STATE OF OHIO
DEPARTMENT OF TRANSPORTATION
SUM-76-10.00
MAIN/BROADWAY INTERCHANGE
CITY OF AKRON, SUMMIT COUNTY

Maintenance of Traffic Subsummary

MOT PHASE 2
I-77 NB TO I-76 WB DETOUR SIGNING

REMOVAL PLAN - RAMP W-5 / VORIS ST.

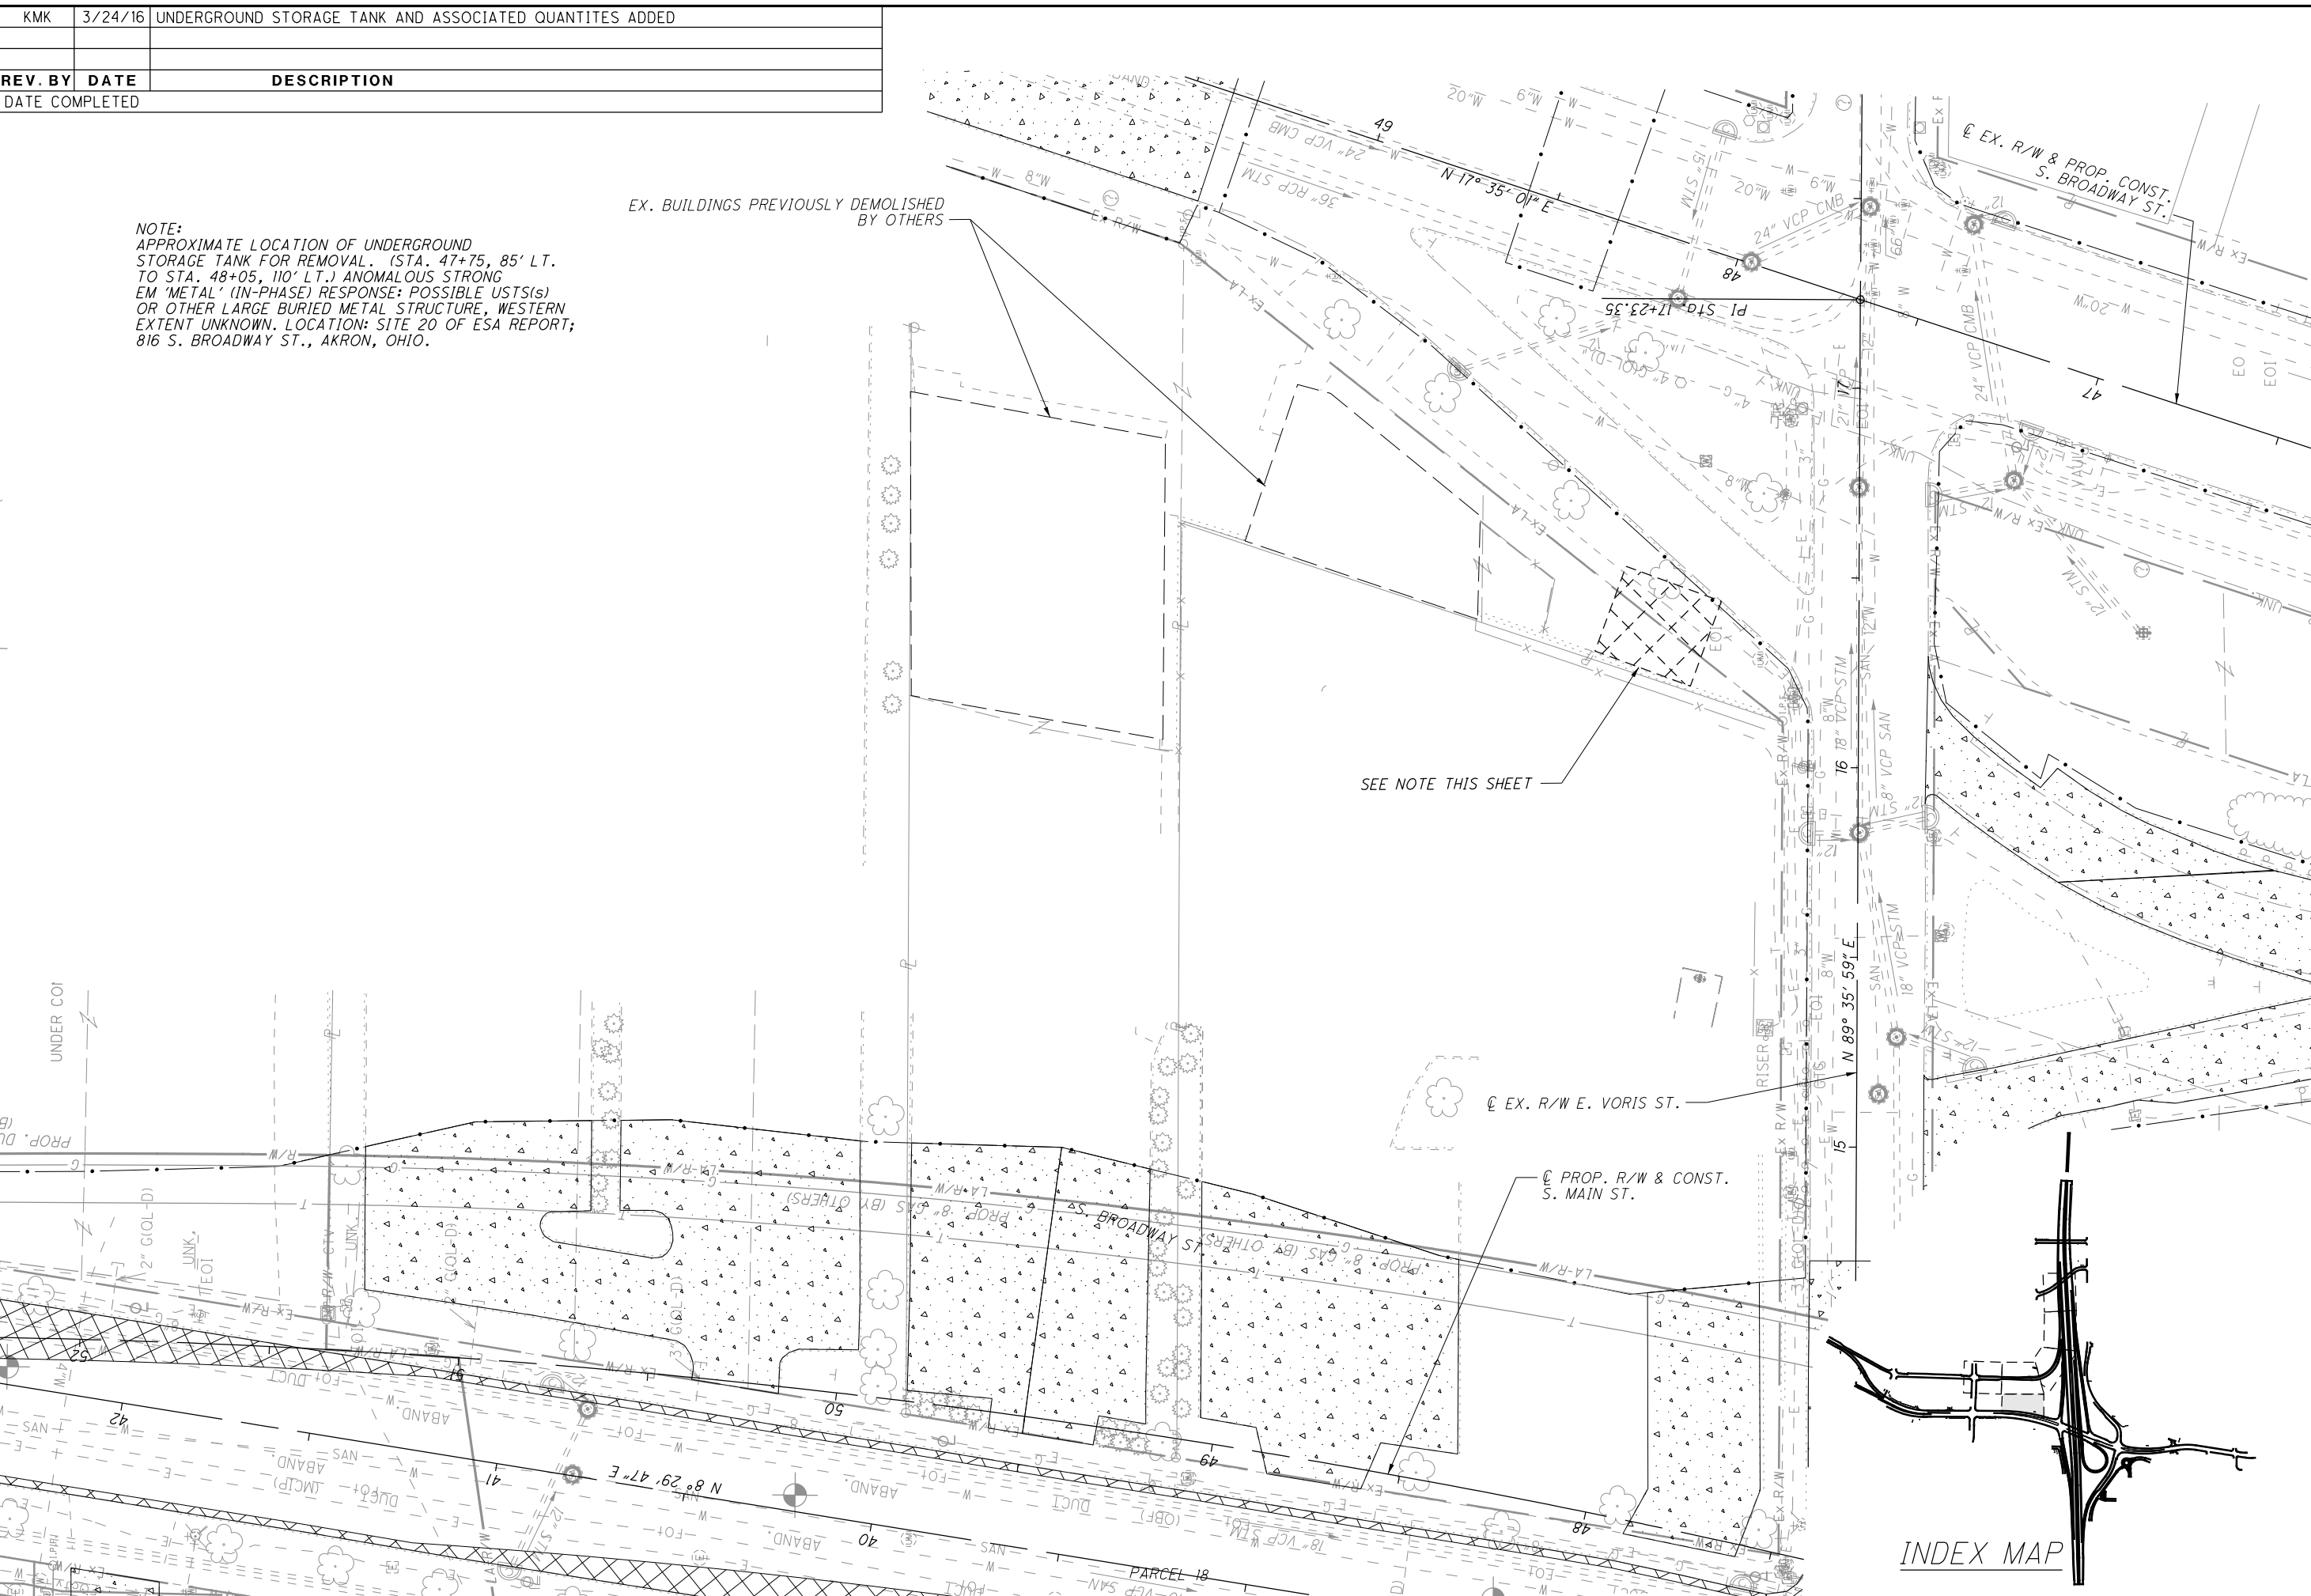
NOTE:
 APPROXIMATE LOCATION OF UNDERGROUND STORAGE TANK FOR REMOVAL. (STA. 47+75, 85' LT. TO STA. 48+05, 110' LT.) ANOMALOUS STRONG EM 'METAL' (IN-PHASE) RESPONSE: POSSIBLE UST(S) OR OTHER LARGE BURIED METAL STRUCTURE, WESTERN EXTENT UNKNOWN. LOCATION: SITE 20 OF ESA REPORT; 816 S. BROADWAY ST., AKRON, OHIO.

ESTIMATED QUANTITIES
BRIDGE NO. SUM-76-1034 L/R
I-76 OVER SOUTH MAIN STREET

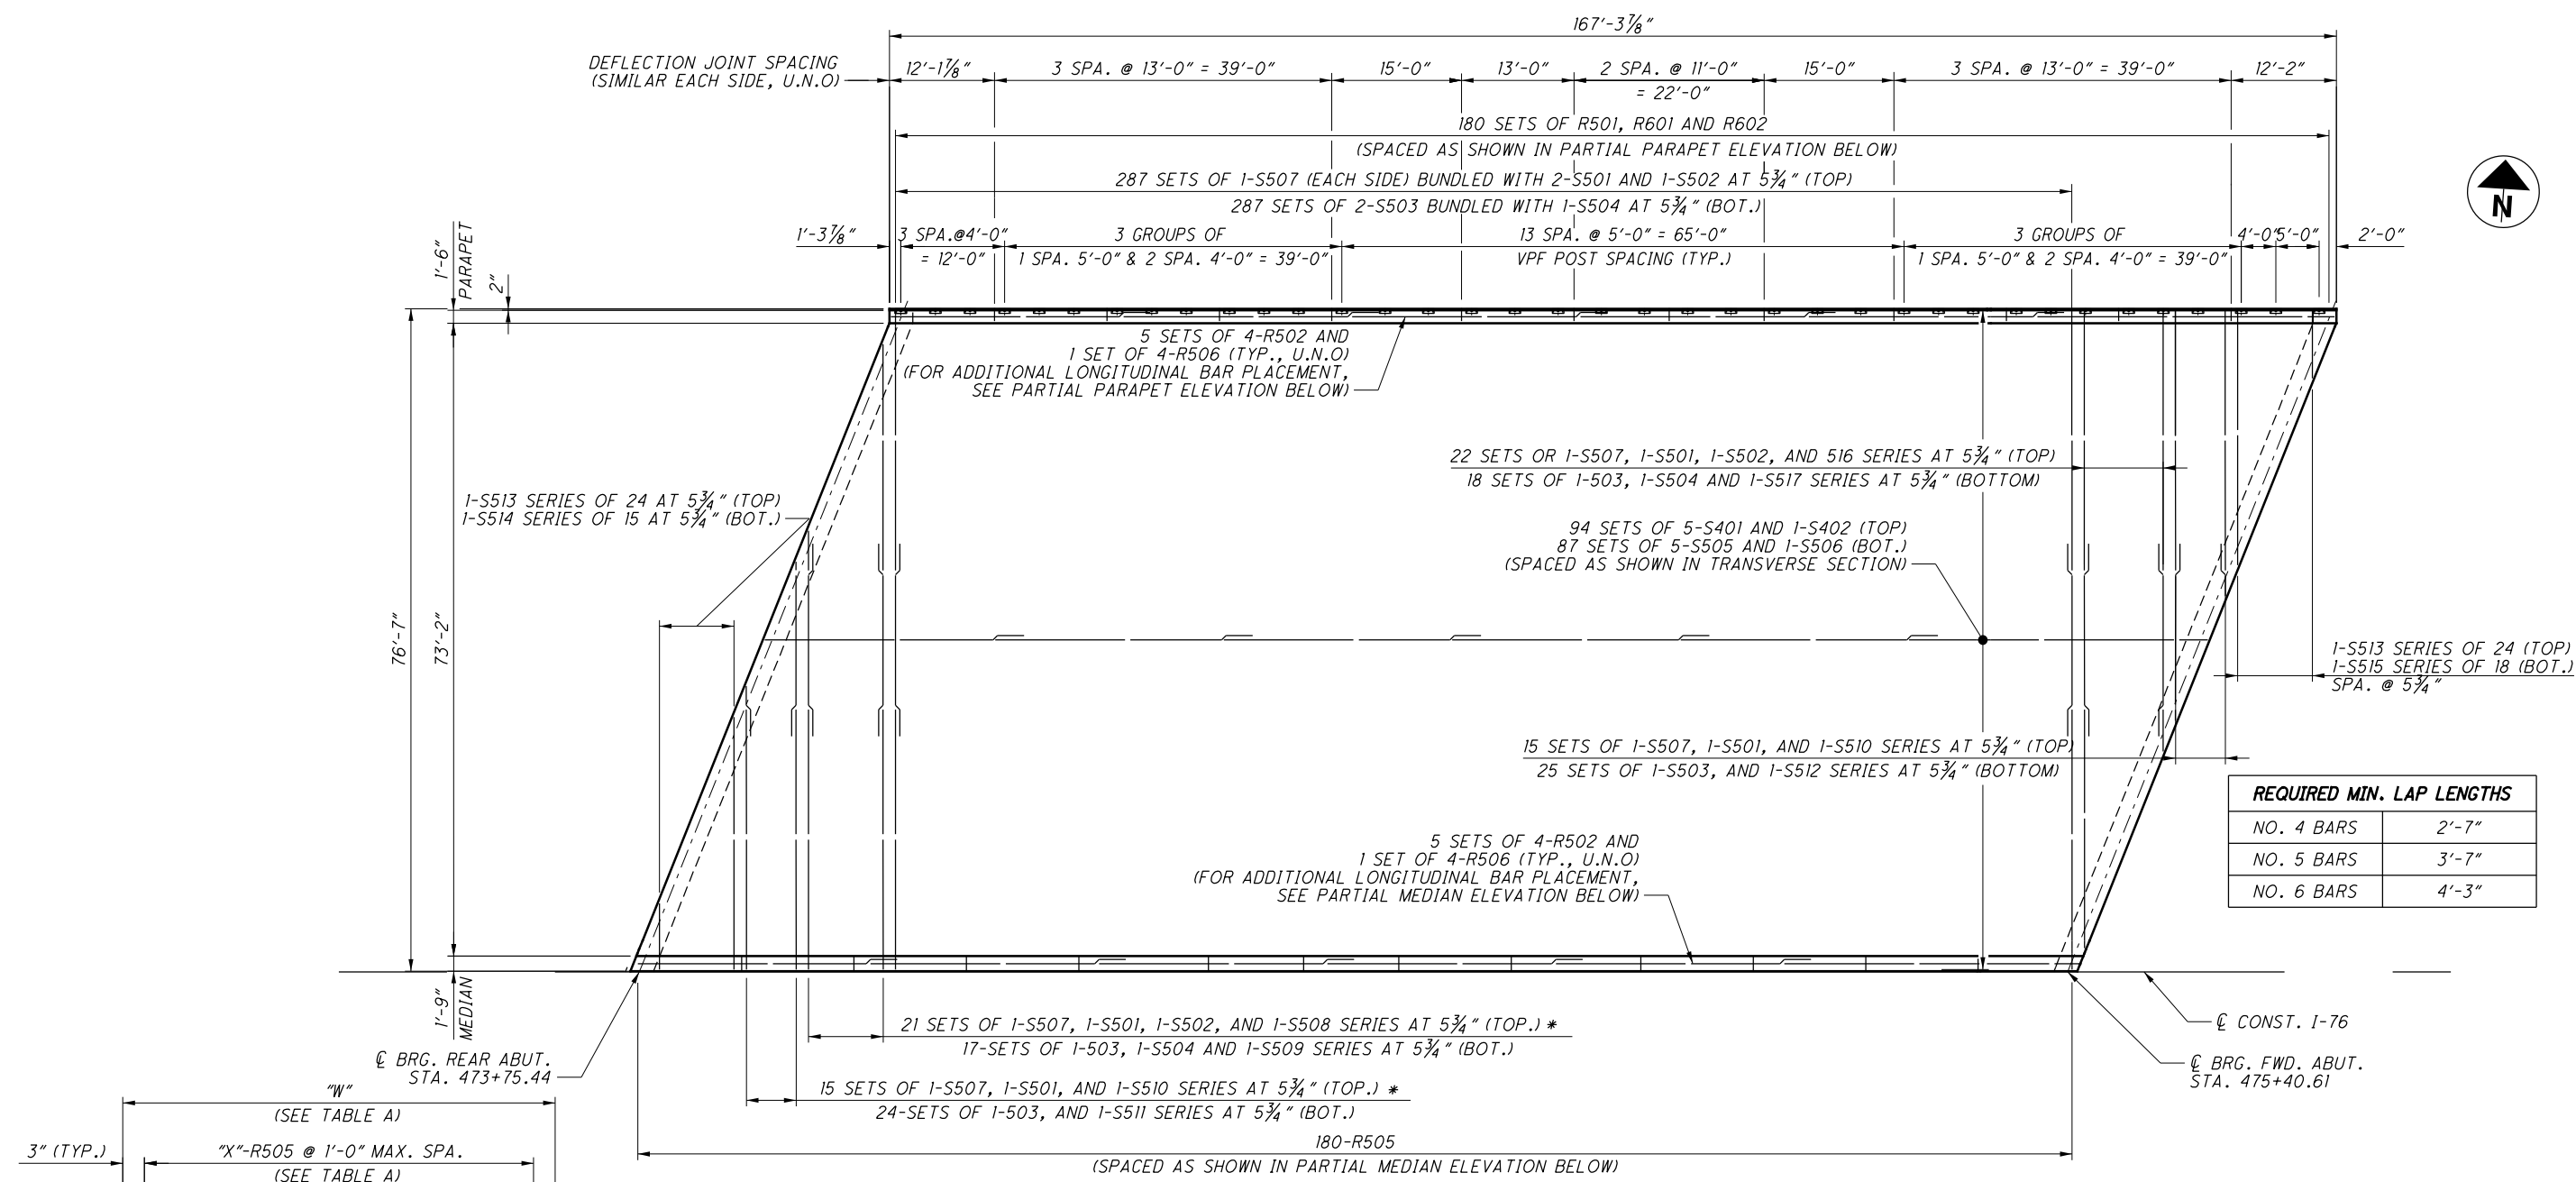
VFG	3/25/16	ADDITION OF VPF FENCE
REV. BY	DATE	DESCRIPTION
DATE COMPLETED
